AXOD/AXODE (AX4S) UPDATE HANDBOOK

*Updated
October, 2002*

Since the introduction of the Ford AXOD transaxle in model year 1986, there have been many major engineering design changes that have affected many of the parts used in the AXOD transaxle. This version of the AXOD "Update Handbook" begins with the 1986 model year and will explain each change, the parts affected by the change, and any parts interchange problems created by the change. This booklet is an updated version of the original.

Figure 54

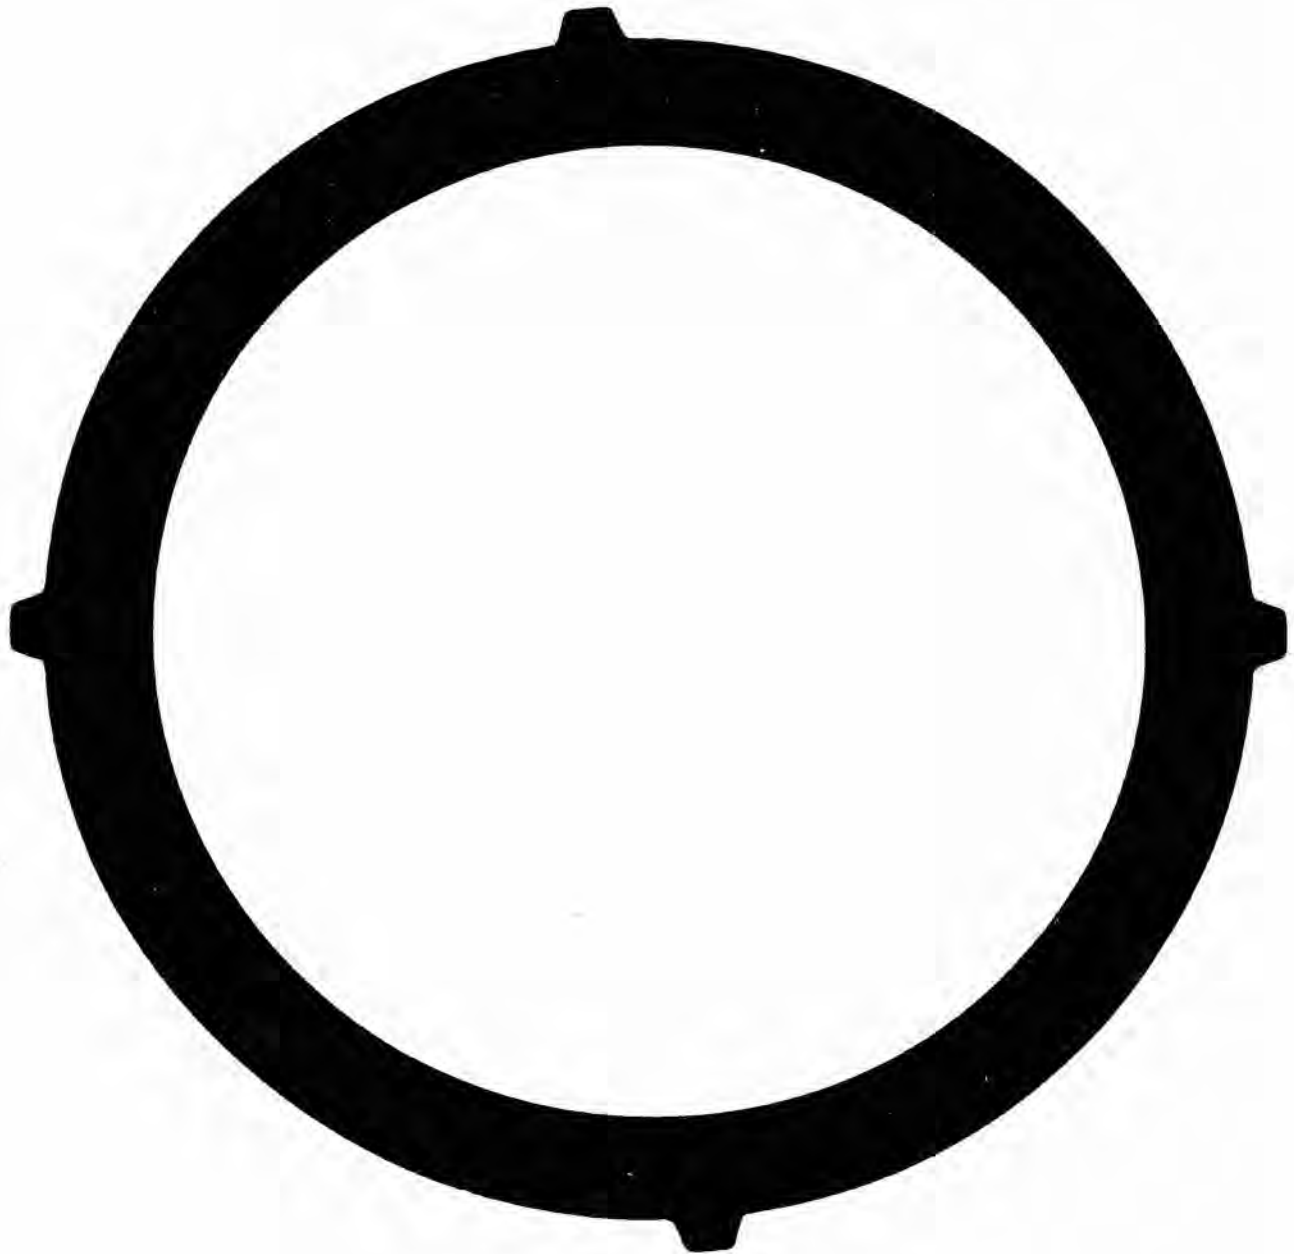
1ST DESIGN - Has 4 external teeth, an inside diameter of 4.715", material thickness of .062", and was used from 1986-1988. Refer to Figure 54.

Figure 55

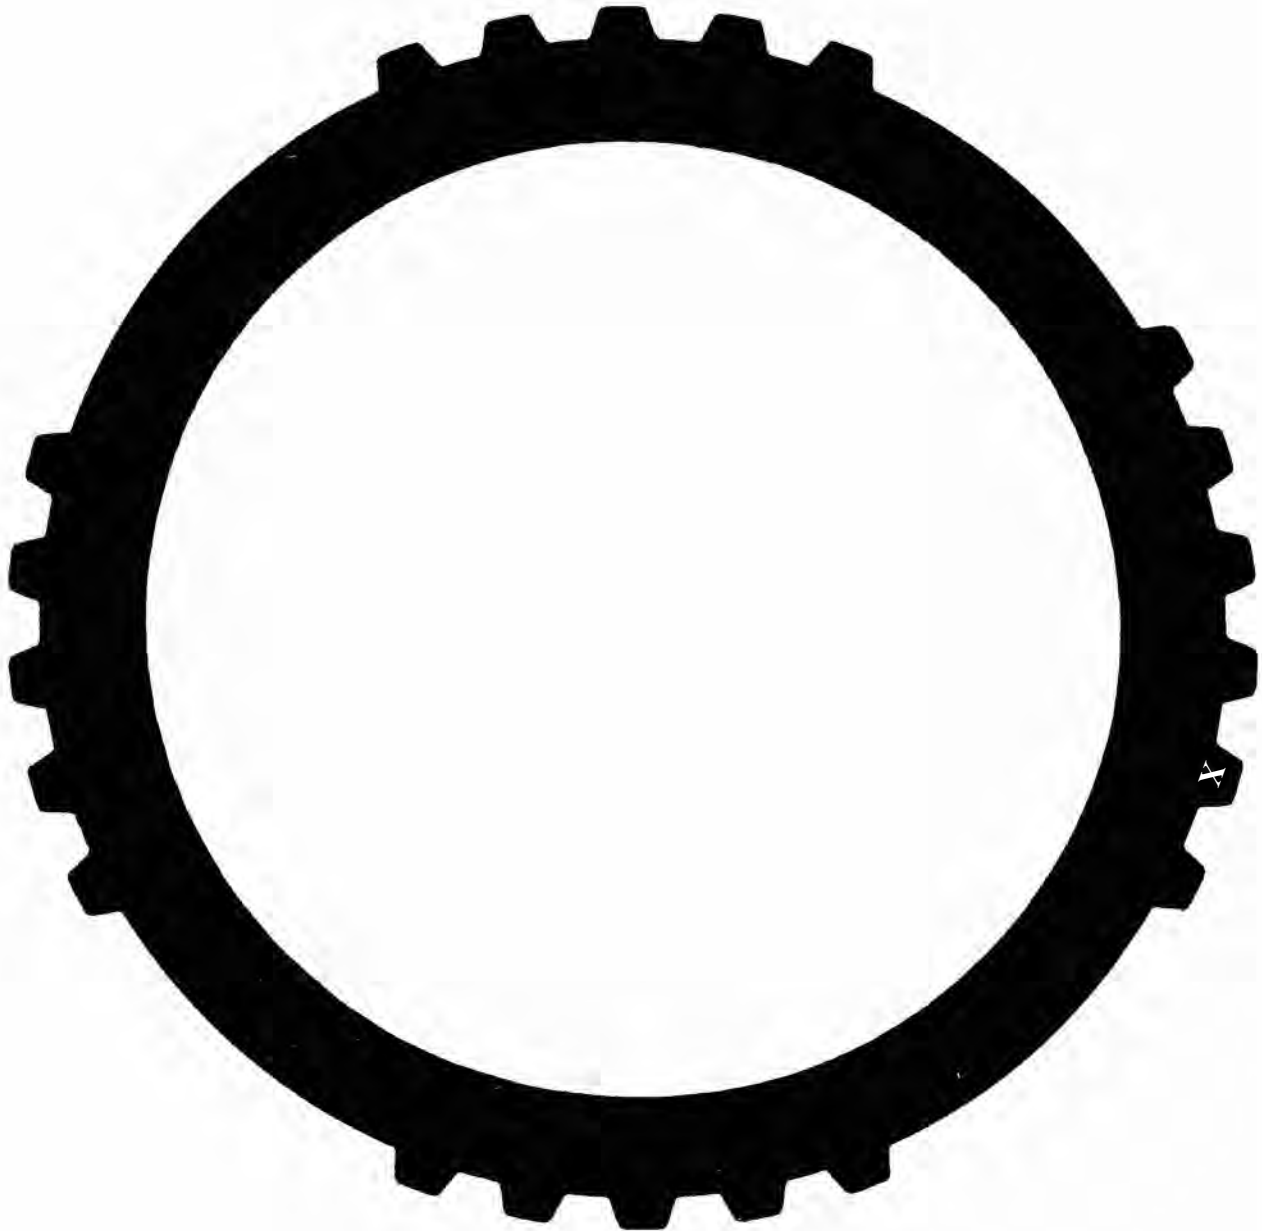
2ND DESIGN - Has 21 external teeth, inside diameter of 4.730", material thickness of .075", identified with letter "X" stamped on 1 tooth, and was used from 1989-1991. (See Figure 55).

Figure 56

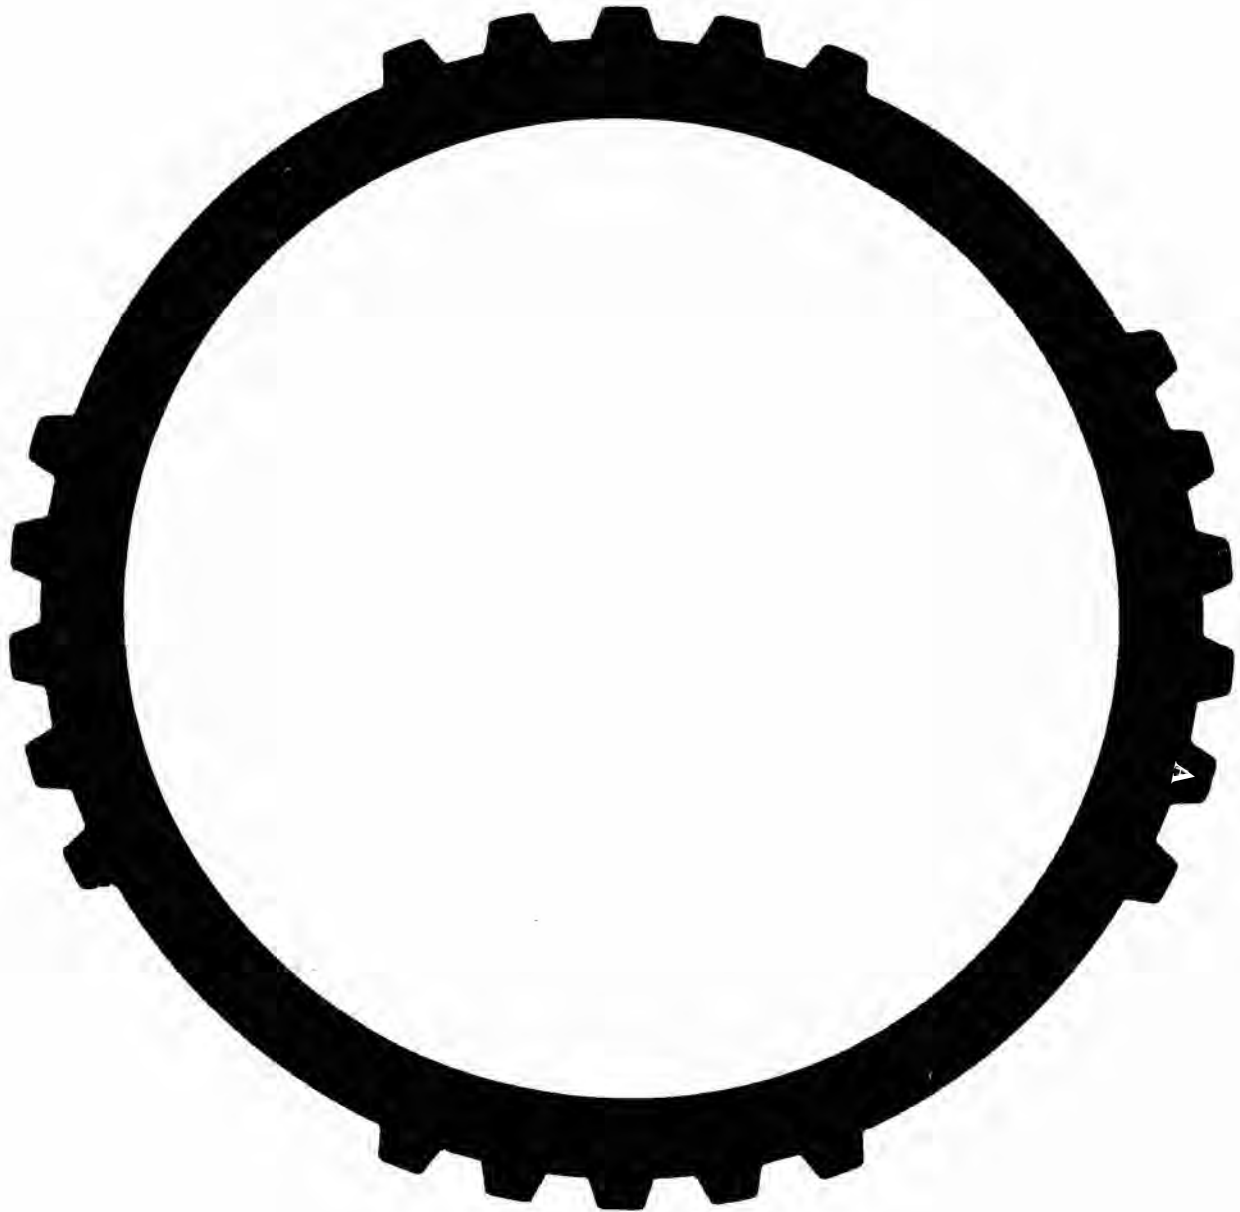
3RD DESIGN - Has 21 external teeth, inside diameter of 4.930", material thickness of .083", identified with letter "A" stamped on 1 tooth, used in 1992 and later models. (See Figure 56).

Figure 57

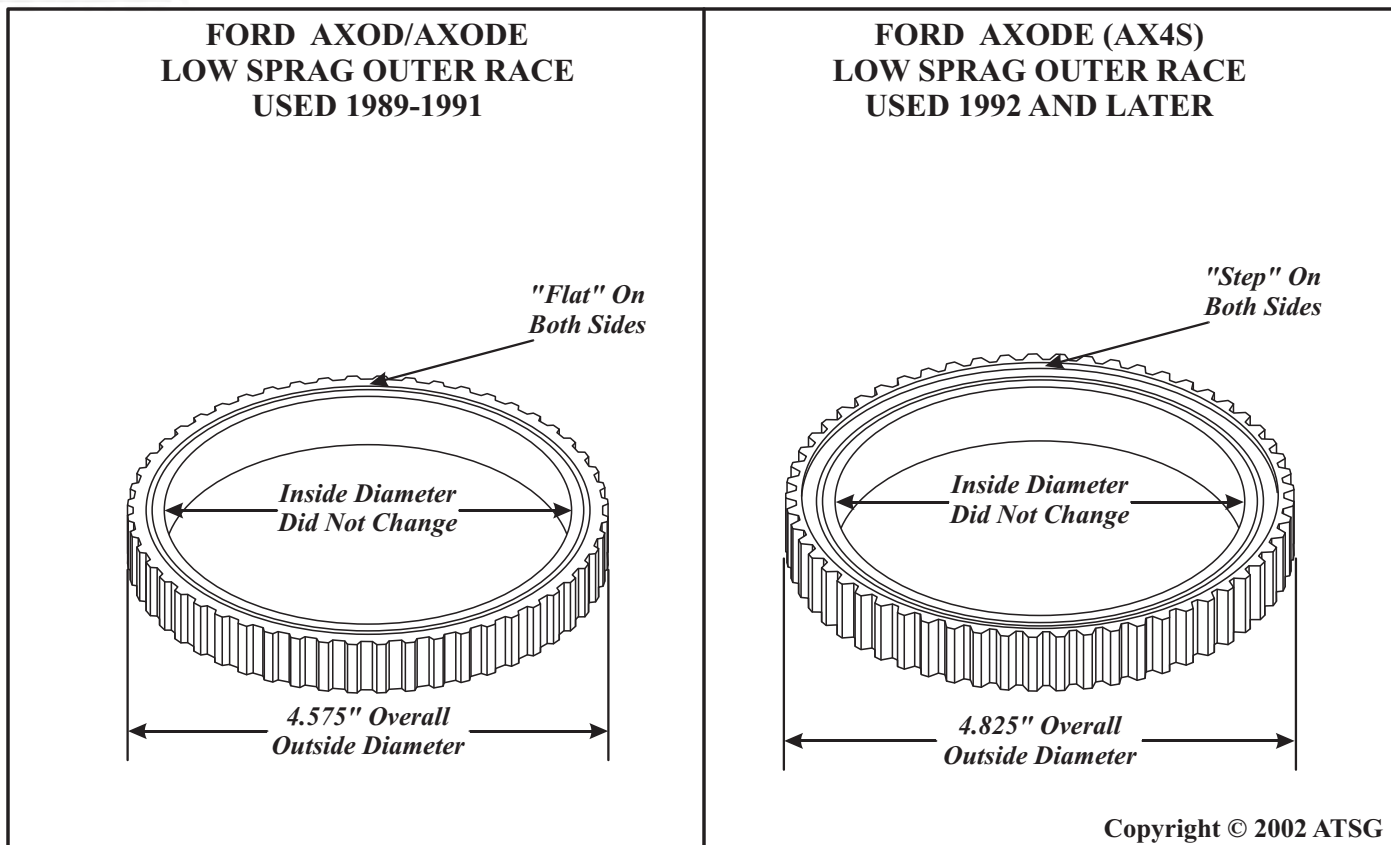
- (1) **LOW SPRAG OUTER RACE** - The outer diameter of the race was increased from 4.575" to 4.825", and the width of the race was increased from .600" to .725", as shown in Figure 57. *The Inside Diameter of the sprag race Did Not Change.*

Figure 58

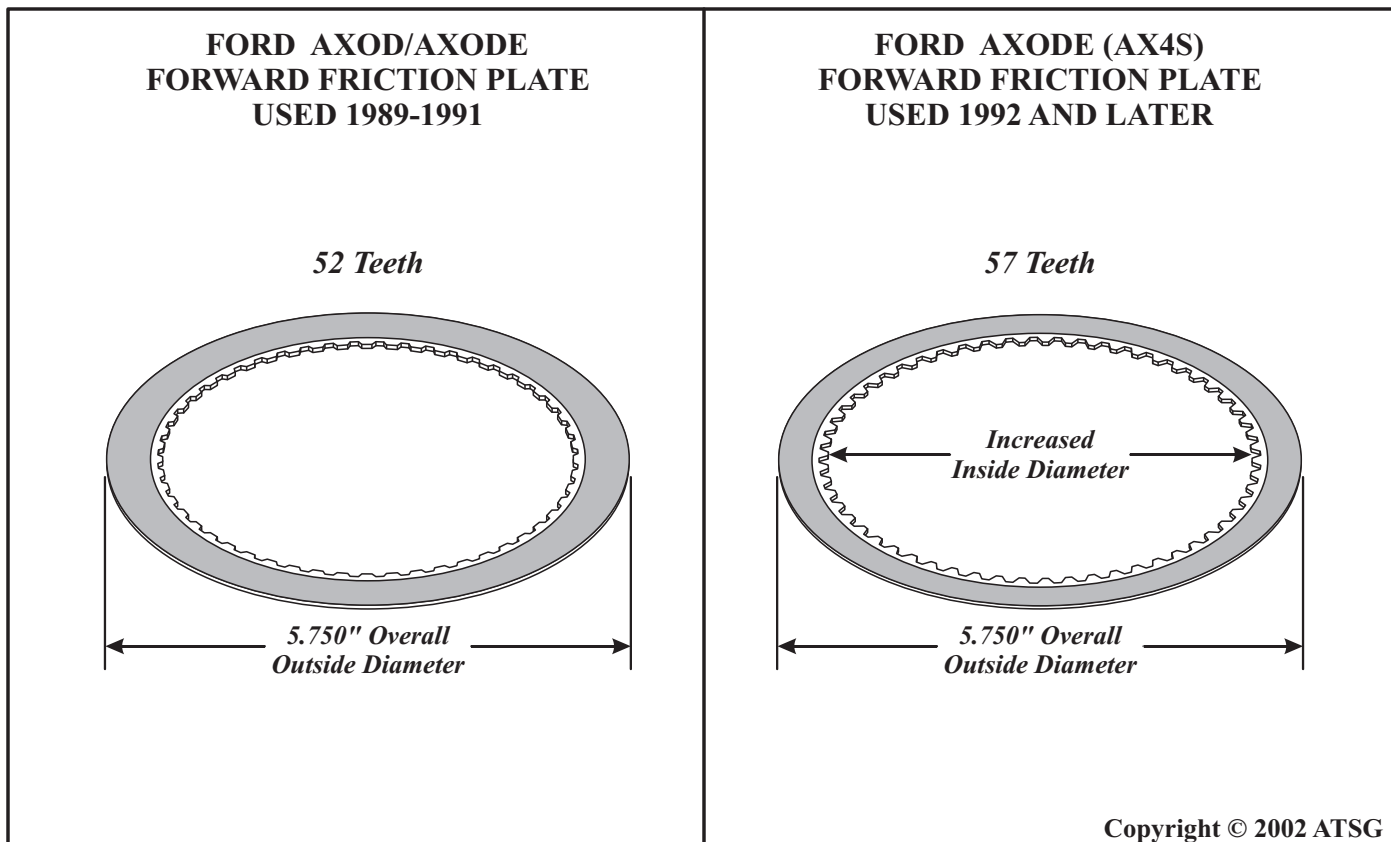
- (2) **FORWARD CLUTCH FRICTION PLATES** - Have an increased amount of teeth to 57 Teeth from the previous 52 Teeth, to accommodate the increased diameter of the sprag outer race, as shown in Figure 58.

Figure 59

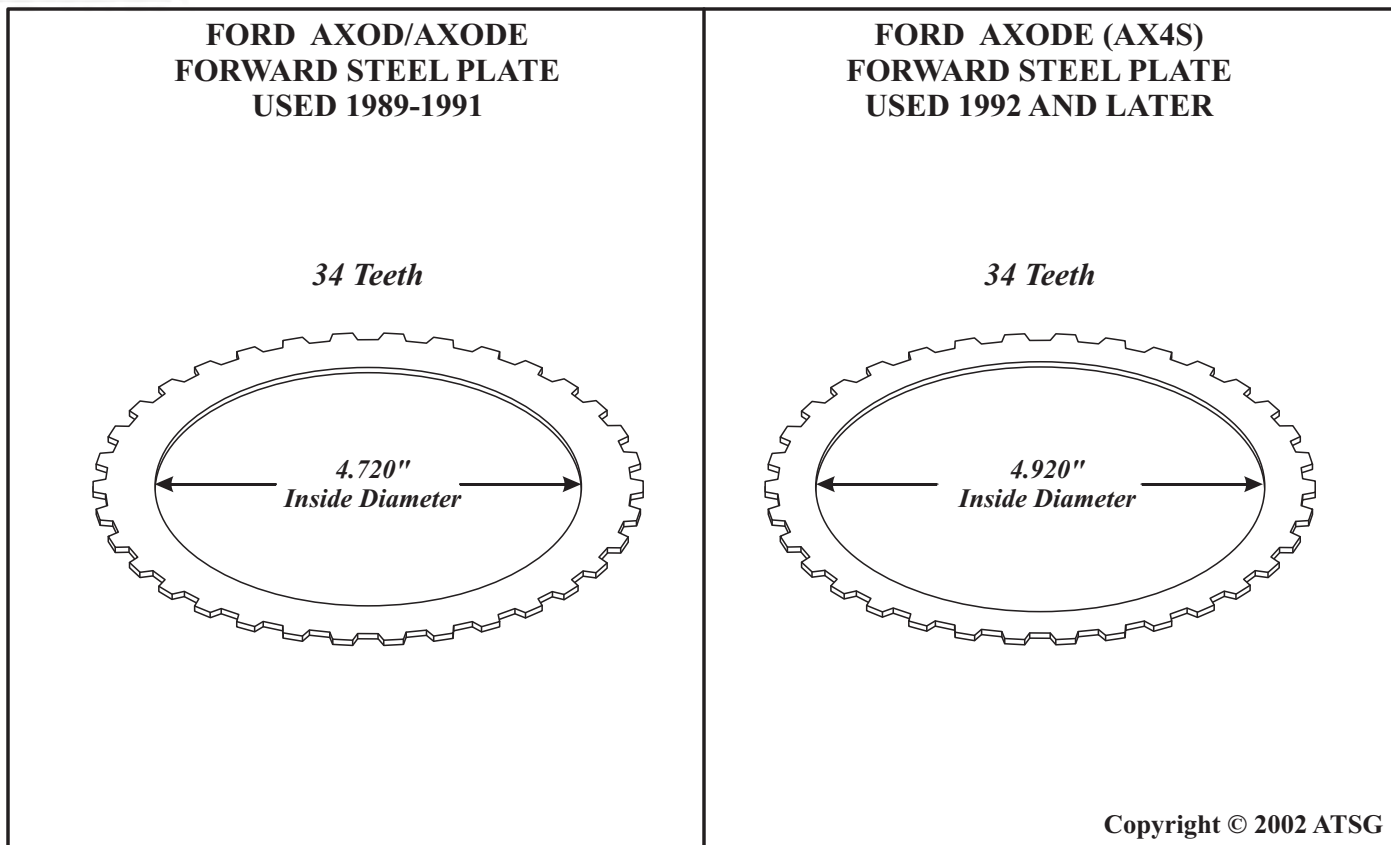
- (3) **FORWARD CLUTCH STEEL PLATES** - Have an increased inside diameter to 4.920" from the previous 4.720", to accommodate the increased diameter of the sprag outer race, as shown in Figure 59.

Figure 60

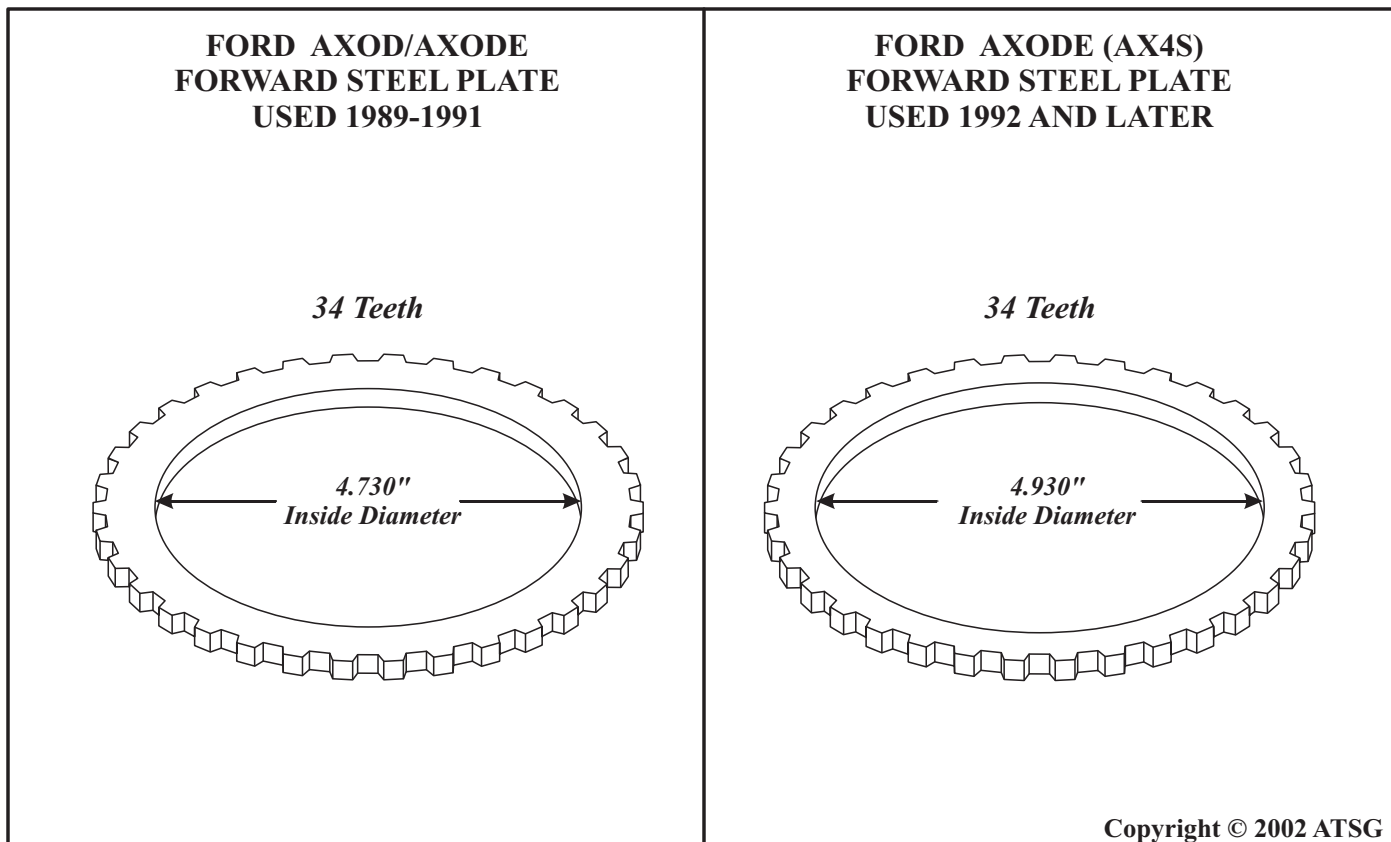
- (4) **FORWARD CLUTCH PRESSURE PLATE** - Has an increased inside diameter to 4.930" from the previous 4.730", to accommodate the increased diameter of the sprag outer race, as shown in Figure 60.

Figure 63

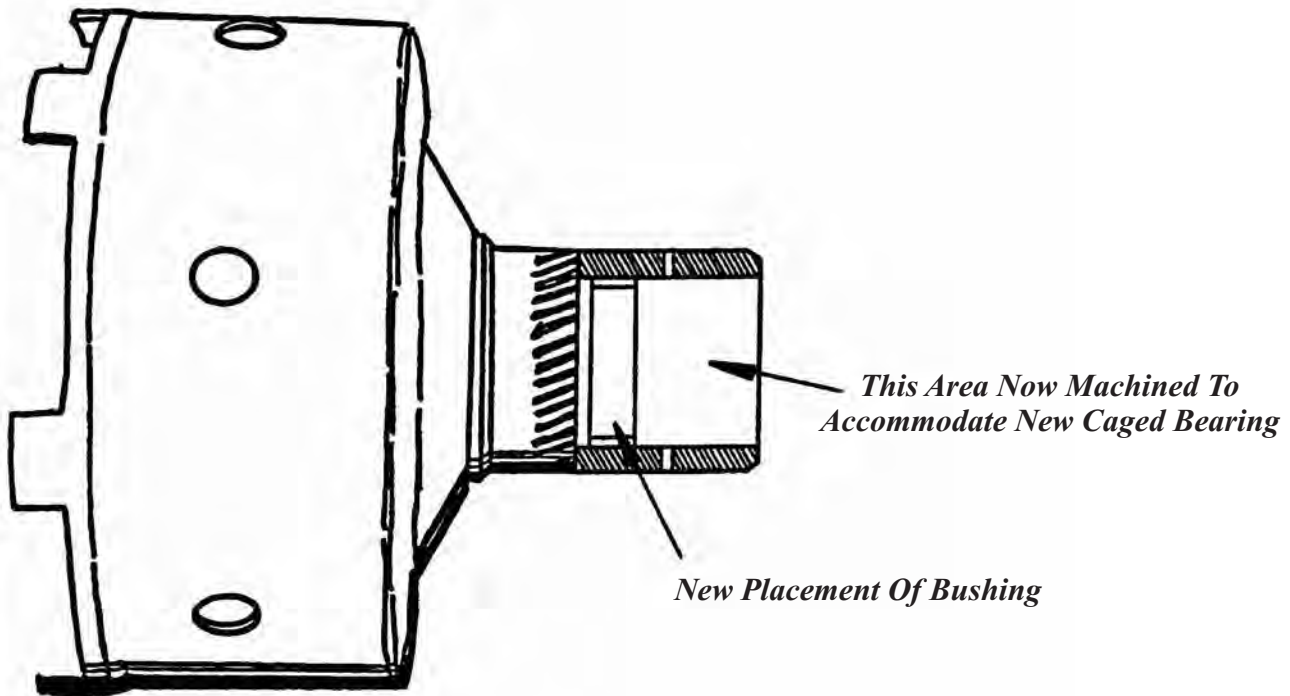
- (1) INPUT PLANETARY CARRIER - New caged needle Bearing added to the shaft on the Input Planetary Carrier, as shown in Figure 62.
- (2) SUN GEAR AND SHELL ASSEMBLY - Single bushing is now located in front of the lube holes in the sun gear, and the area behind is now machined to accommodate the new caged needle bearing, as shown in Figure 63.
